30B valve geometry in the DN30 safety assessment

0023-PRT-2024-012

Meeting agenda

IRSN question on valve geometry

Initial housing design

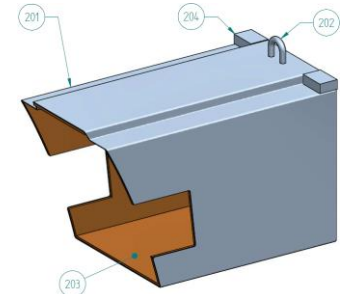
Performed 2x (before 2nd and 3rd fire test) with initial housing design

Series design without 10 mm extension on top
10.2 m drop showed no contact valve / housing

Conclusion from tests: gap of at least 10 mm for series design

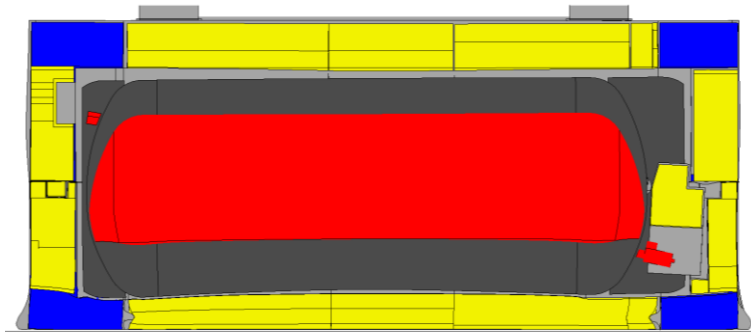
With corrected valve geometry, small valve/housing gap estimated

SQ 8 drop test orientation

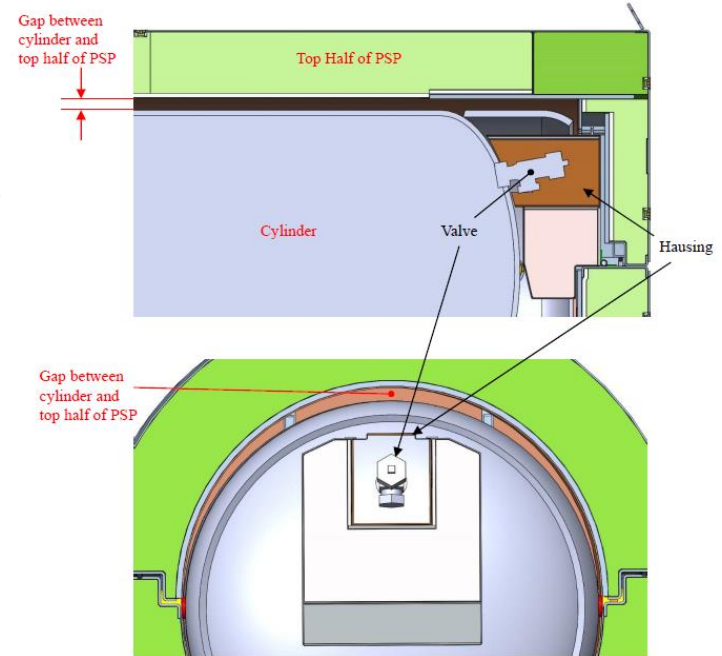
Penalizing drop test orientation for valve gap is now drop sequence SQ8

Corrected valve geometry leads to narrow margin for the valve/housing distance

Solution: removal of the housing

- Increases global safety margins so that valve contact is not an issue anymore
 - Thermal safety: only small effect due to efficiency of thermal insulation
 - Structural safety: removes any risk of valve contact, no other consequences
-
- Also needs to be implemented for the DN30-X package (USA/9388/AF-96)
